***** IMPORTANT SAFETY RECALL *****
NHTSA Recall No. 19E020
Interim Recall Notice

Cummins Inc. has decided that a defect which relates to motor vehicle safety exists in certain B6.7 diesel engines that were manufactured between December 16, 2015 and February 25, 2019 and equipped with fuel module option FS90301 or FS90453.

Figure 1 - Location of Fuel Filter Module & Heating Element

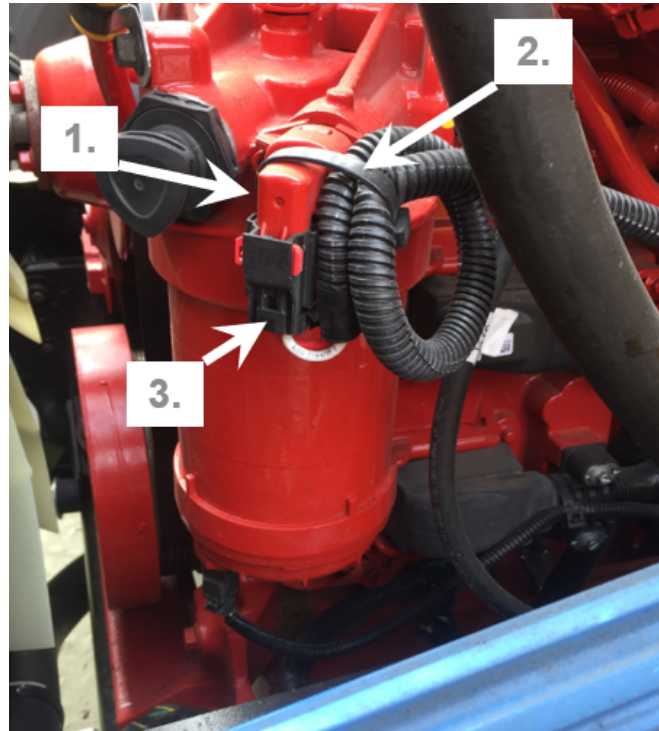
- Locate the fuel filter module and fuel heater at the driver's side front of the engine as shown in Figure 1 below.
- Inspect the heater and module for any signs of damage or fuel leakage.
- If there is no damage or leakage after engine shutdown, remove the fuel heater fuse as shown in Figures 2 or 3 below (based on application) and leave the wiring harness connected.
- In the event there are signs of damage OR leakage, contact your local Cummins service location at the number below to have a heater plug kit installed. (Reference TSB190038)

Figure 2. Navistar® CE Bus Fuse Removal Instructions

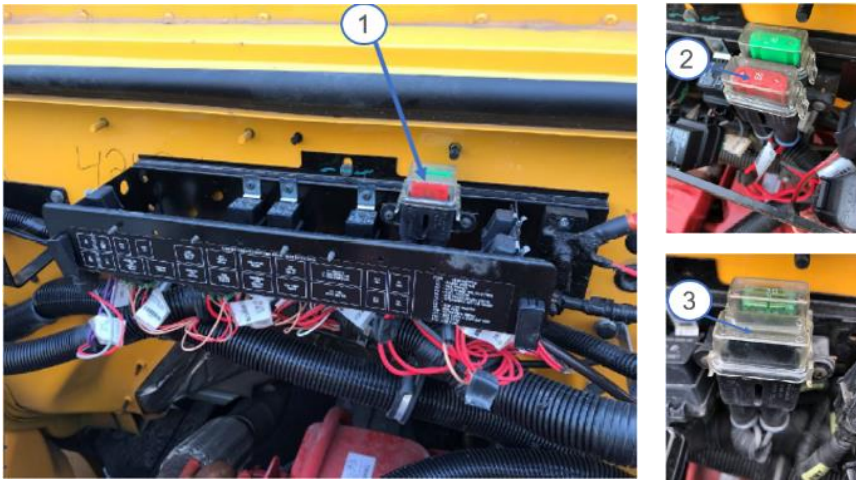
1. Locate red Maxi Fuse on dash panel. See Figure below.
2. Remove fuse cap and discard red Maxi Fuse. See Figure below.
3. Reinstall fuse cap. Do **not** replace fuse. See Figure below.
4. Retain fuse for reinstallation once final remedy is performed.

Location of 20A Fuse on Navistar® MV/HV.

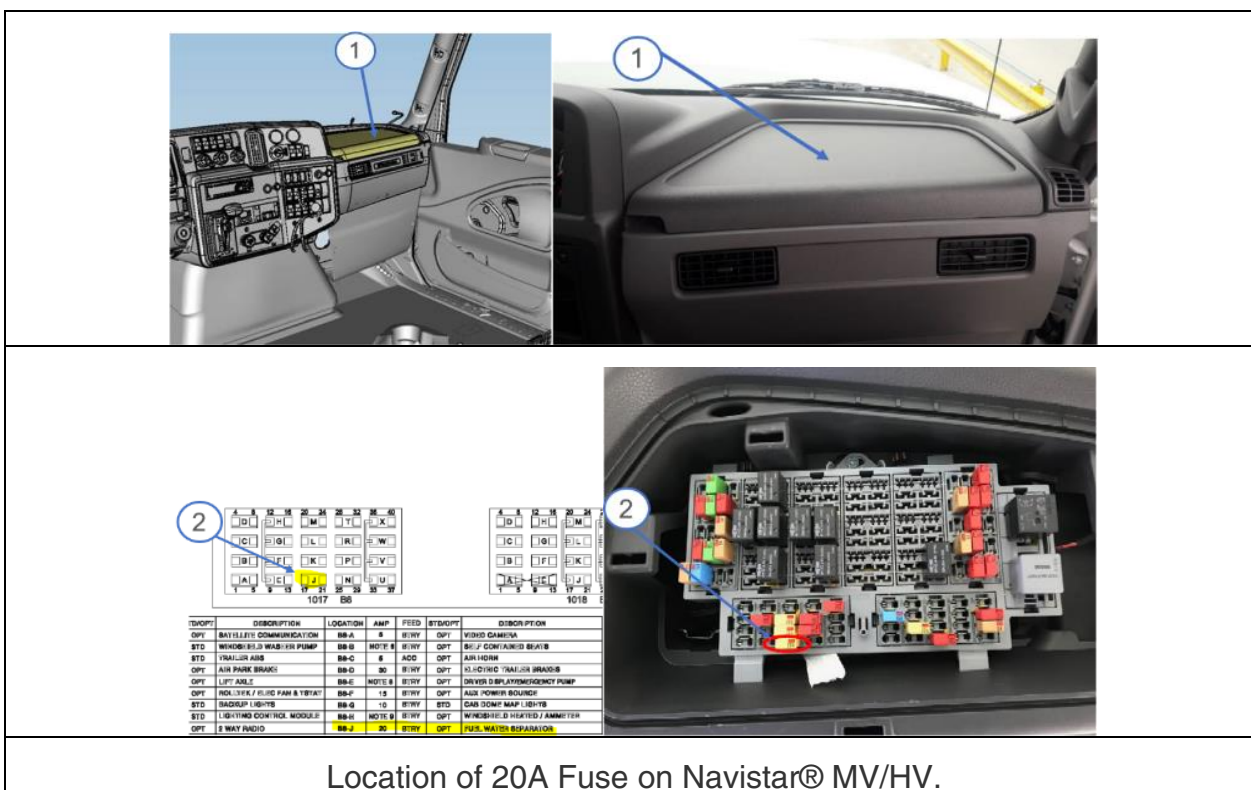
1. Remove cover of fuse box, located on passenger side dashboard as indicated in the photo below.
2. Remove 20 amp fuse located at B8-J cavity 17-21 as indicated in the photo below.
3. Remove 40 amp fuse located at 2C cavity as indicated in the photo below..
4. Retain fuses for reinstallation once final remedy is performed.
